ABINGTON TOWNSHIP

PLANNING COMMISSION MEETING

**RE: Executive Summary for LD-25-01 – 1526 Fairview Avenue
PARID: 30-00-18860-00-1/ TMID: 30196 017
Preliminary/Final Major Subdivision & Land Development Plans Review (2nd Submission)**

RE: LD-25-01 – 1526 Fairview Avenue
PARID: 30-00-18860-00-1/ TMID: 30196 017
Preliminary/Final Major Subdivision & Land Development Plans Review (2nd Submission)

RECORD PLAN (SHEET 1 OF 1 TO BE RECORDED)

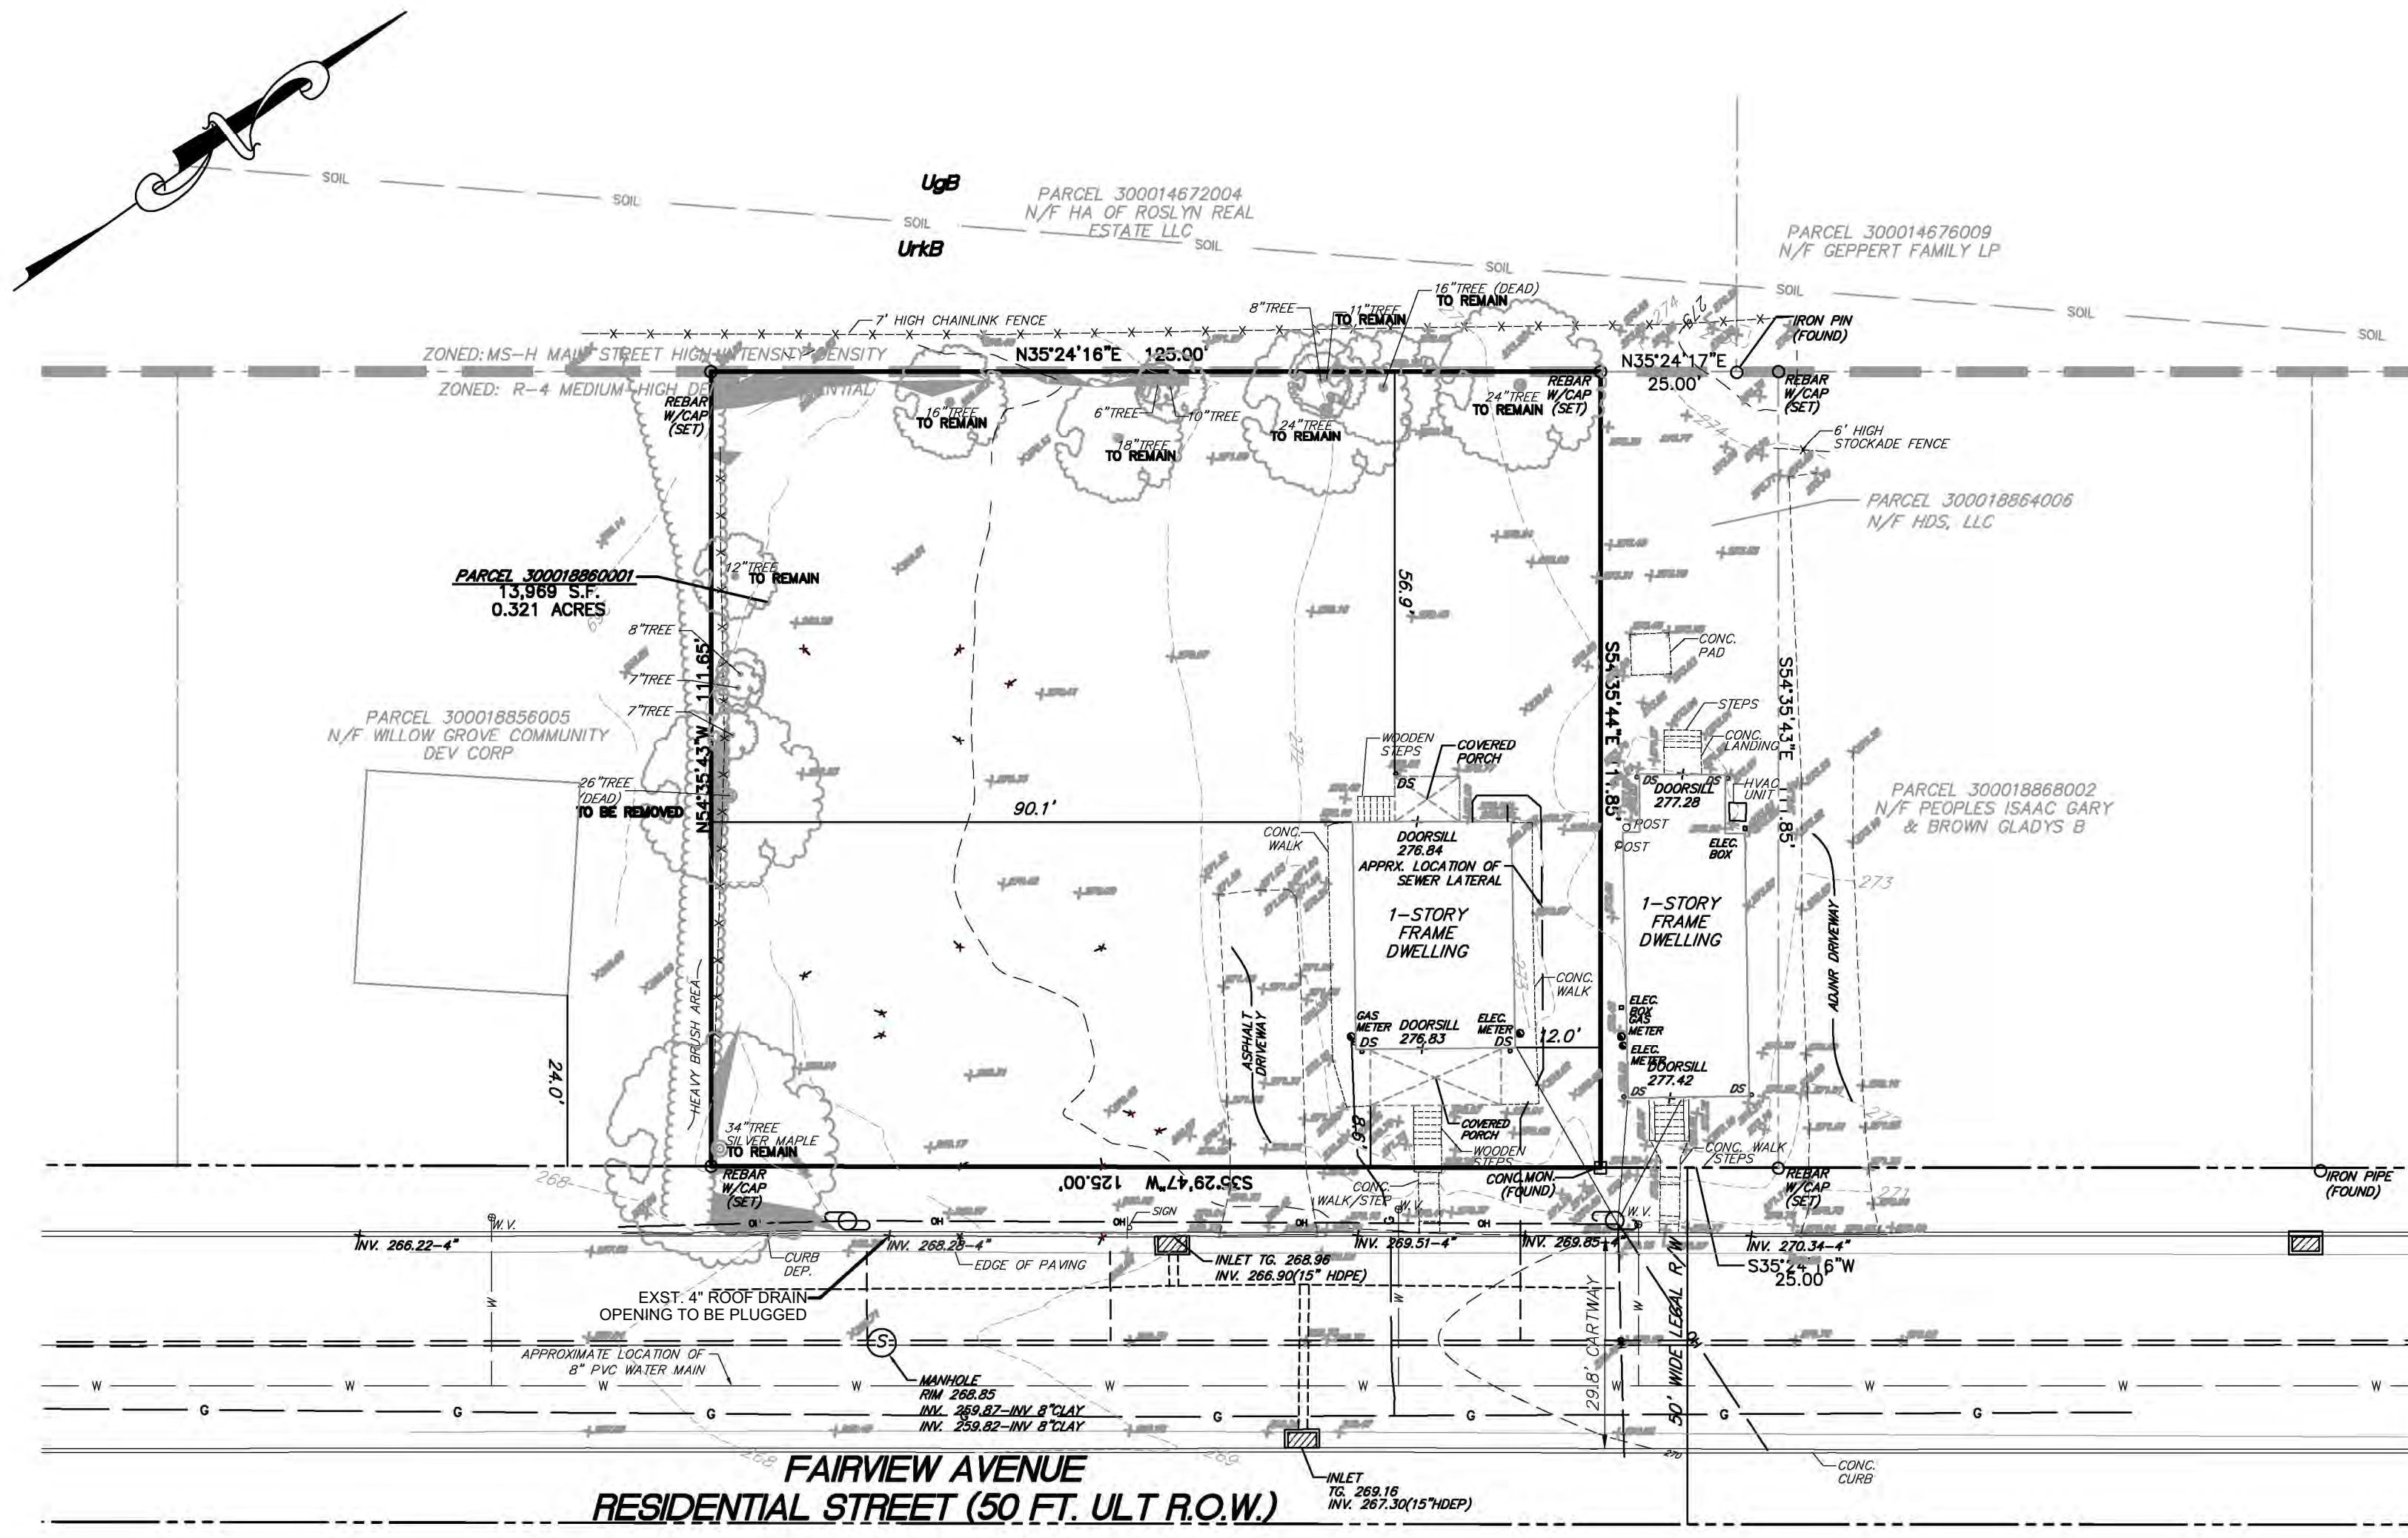
Provide additional room for the seal of the Township Engineer to ensure no text overrides with the secretary's signature line above in the "Board of Commissioners Approval" signature block on the Record Plan (Sheet 1).

4. Plan sheets to be recorded shall be indicated on the Record Plan (Sheet 1). Plans to be recorded shall include Sheets 1, 3, 4, and 8.

52. The Index of Sheets on the Record Plan (Sheet 1) shall indicate which plans are to be recorded.
53. The narrow longitudinal zoning district abutting the R4 zoning district located to the east of the site on the Location Map is mislabeled as "MS-H" and should be corrected to the "MS-L" zoning district. Similarly, the "MS-H" label for the horizontal area between Arnold Avenue and Fairhill Avenue should also be corrected to the "MS-L" zoning district.

Township of Abington
STANDARD DETAIL - SEWER SYSTEM
TYPICAL BUILDING SEWER CLEANOUT ASSEMBLY

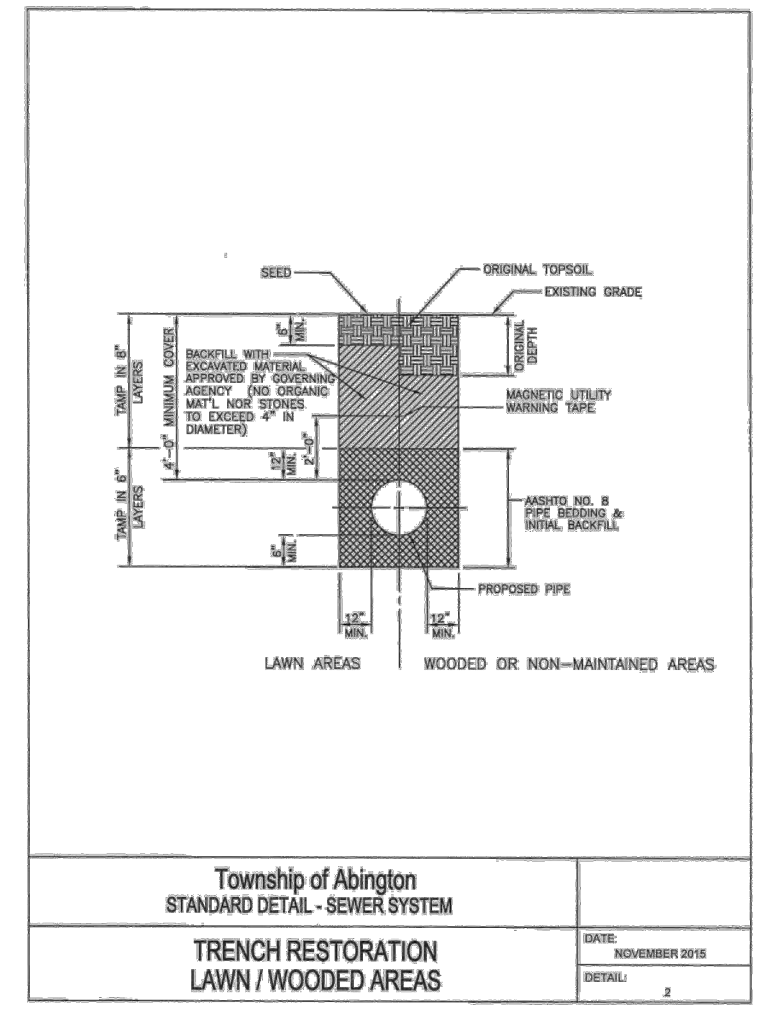
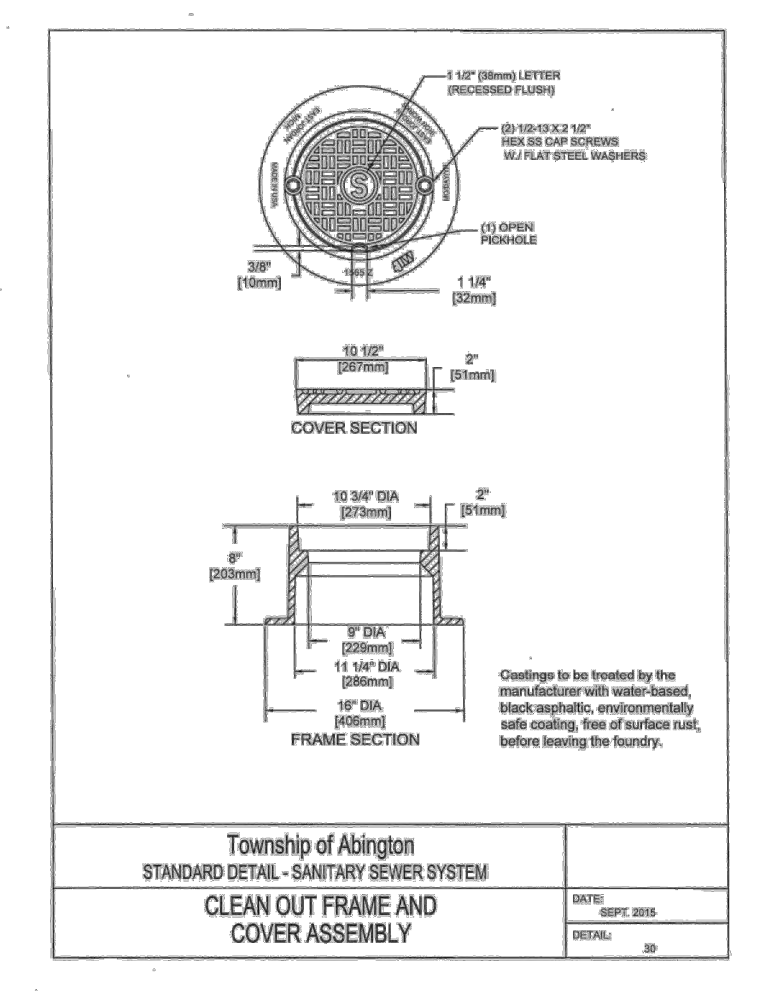
- The "Typical Cleanout Detail (Paved Areas)" and the "Typical Cleanout Detail (landscape Areas)" should be removed from the plans and replaced with the Township of Abington Typical Building Sewer Cleanout Assembly which utilizes a 2-way cleanout tee fitting. The proposed cleanout adjacent to the driveway apron should also be protected by a cleanout frame and cover assembly which should be added to the Construction Details Sheet. Also, the Township of Abington Trench Restoration Lawn/Wooded Areas should be added to the Construction Details Sheet.

OUTLET CONTROL STRUCTURE
(NOT TO SCALE)

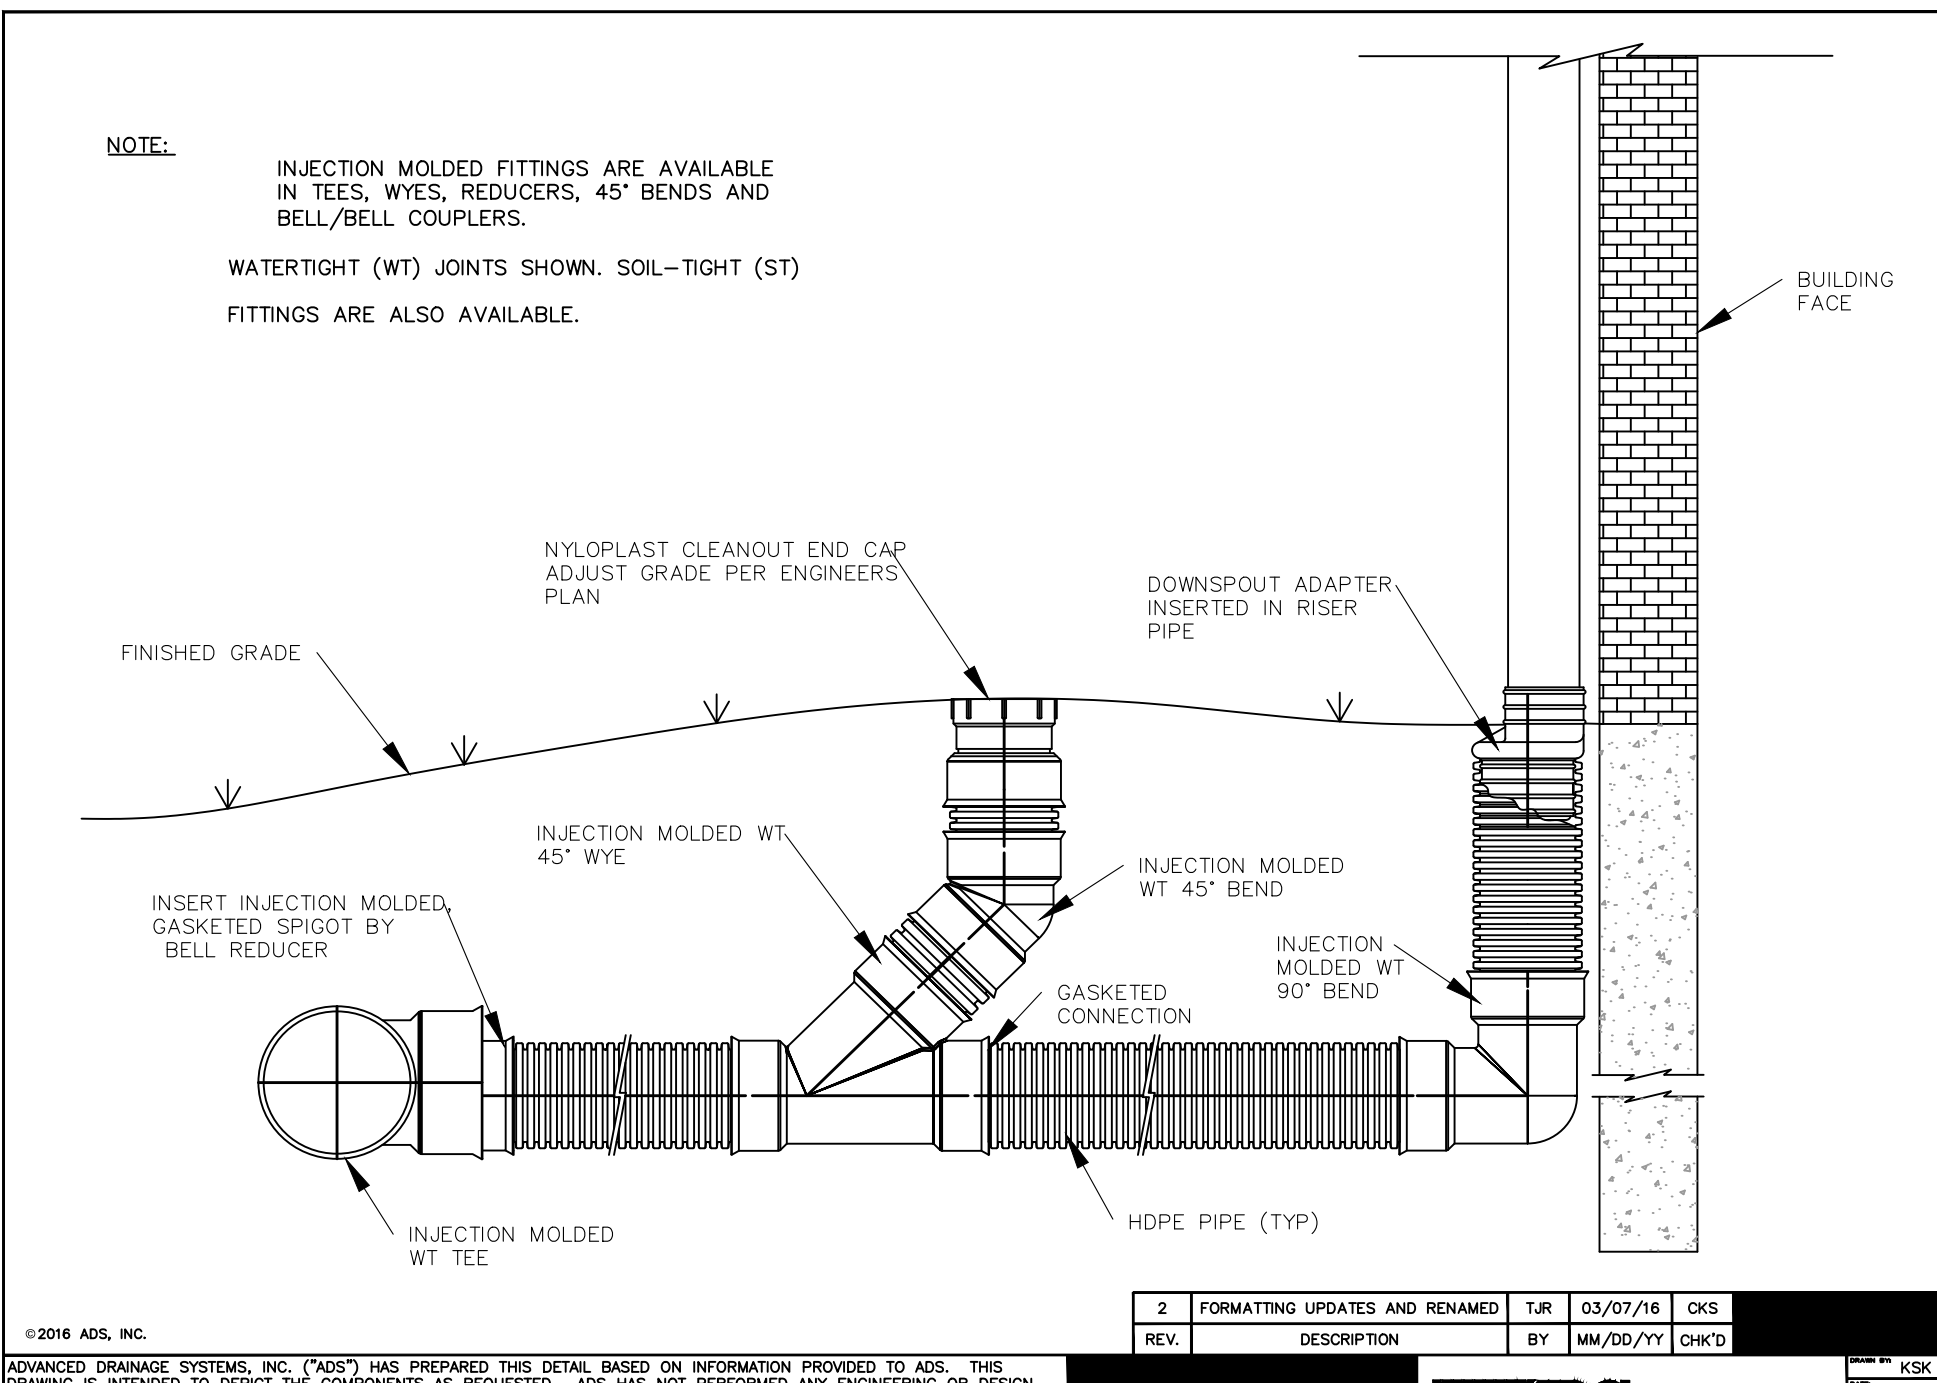
- Add flow dissipator or rip-rap apron for the downspout discharge pipe into the raingarden.
 - On the Outlet Control Structure Detail provided on the plans, the inlet pipe is labeled as 15"; however, on the plans, the inlet pipe is a 4" perforated pipe. The detail shall be revised accordingly.

2 H-7 INFILL DEVELOPMENT HEIGHT REQUIREMENT

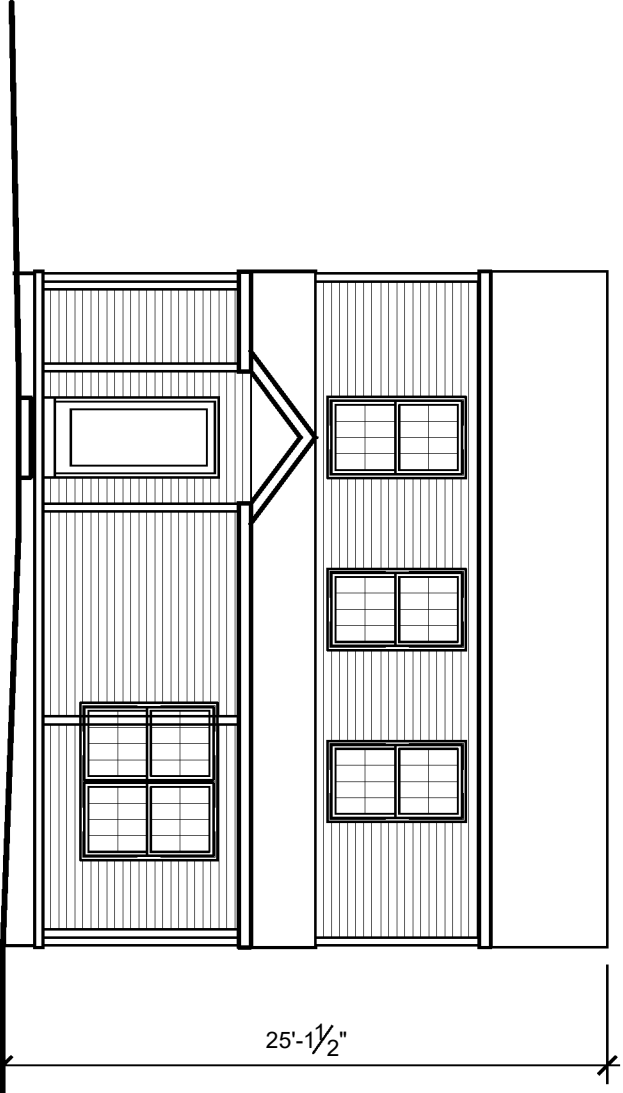
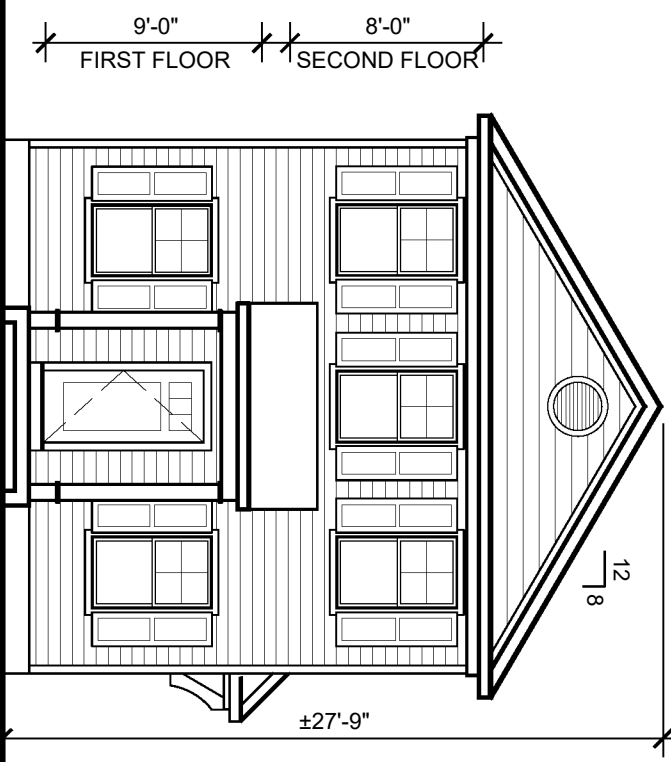
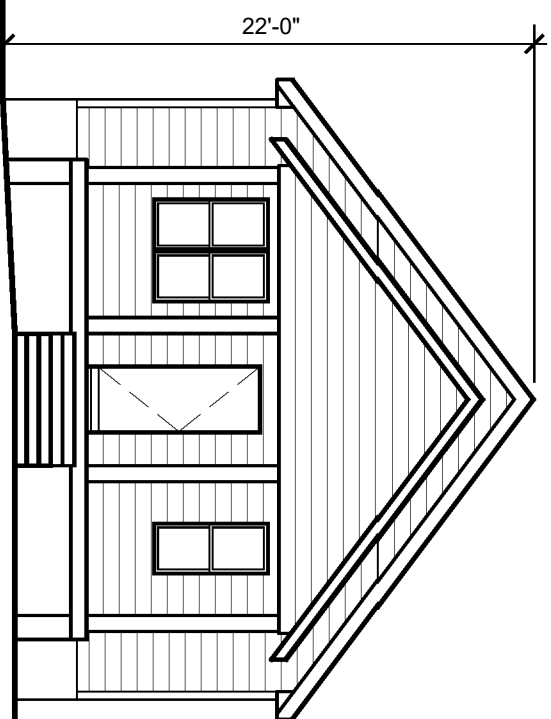
Based on our measurements of the Architectural Plans provided, the height and length of the proposed dwellings will be approximately 24 feet high and 52 feet long, respectively, which complies with the building height and length requirements. The Applicant shall revise the Zoning Data Table on the Site Plan (Sheet 1) to show the actual proposed building height and length to clarify and ensure compliance with this Code Section.
